Data Sheet Specification Correction for Intersil ZL6105ALAF* Products

**Refer to:
PA12097**

Products affected: **ZL6105ALAF ZL6105ALAFT ZL6105ALAFTK**

New POD L36.6x6C – PA12097

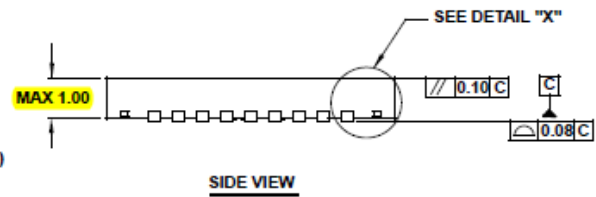
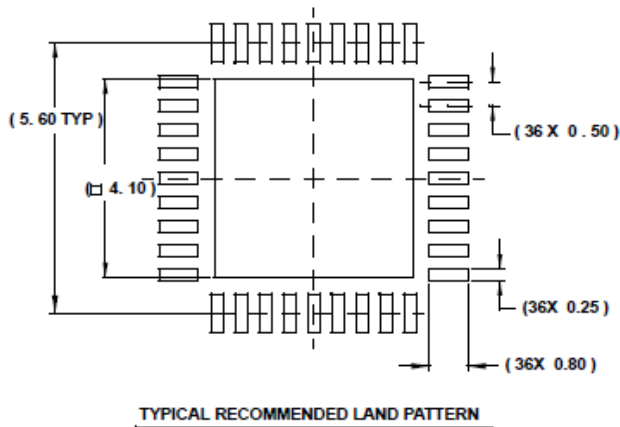
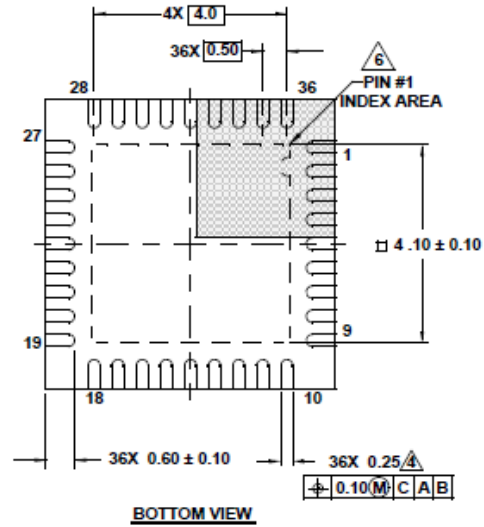
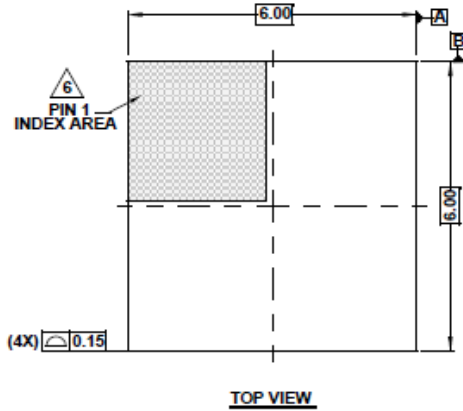
This advisory is to inform you that Intersil has made corrections to the POD (Package Outline Drawing) referenced in the data sheet specification for the ZL6105ALAF* products. The updates to the POD correct the thickness (height) of the package body. The old and new PODs are contained on following pages. There have been no changes to the package or product itself. The updated data sheet is available on the Intersil web site at <http://www.intersil.com/content/dam/Intersil/documents/fn69/fn6906.pdf>.
